Safety News

Blue Ember Grills: Retrofit Blue Ember grills without a heat shield with a new grease pan / heat shield.

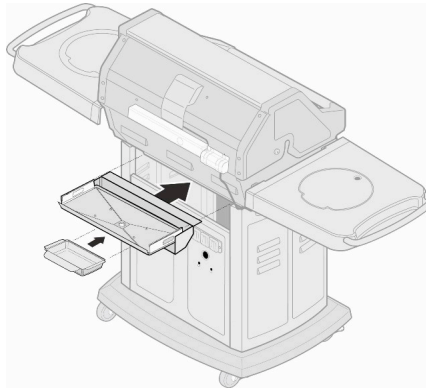
Problem:

In Blue Ember grills without heat shields, if the propane tank or natural gas hose is improperly installed, the propane hose or natural gas hose can be exposed to excessive heat, posing a risk of fire hazard. Owners of affected Blue Ember grills should replace the original grease pan with a new grease pan/heat shield, available free of charge from Fiesta Gas Grills, LLC. The replacement grease pan is designed to also act as a heat shield to protect the hose from being exposed to excessive heat from the firebox.

Owners of affected Blue Ember grills should install the new grease pan / heat shield before using the grill again.
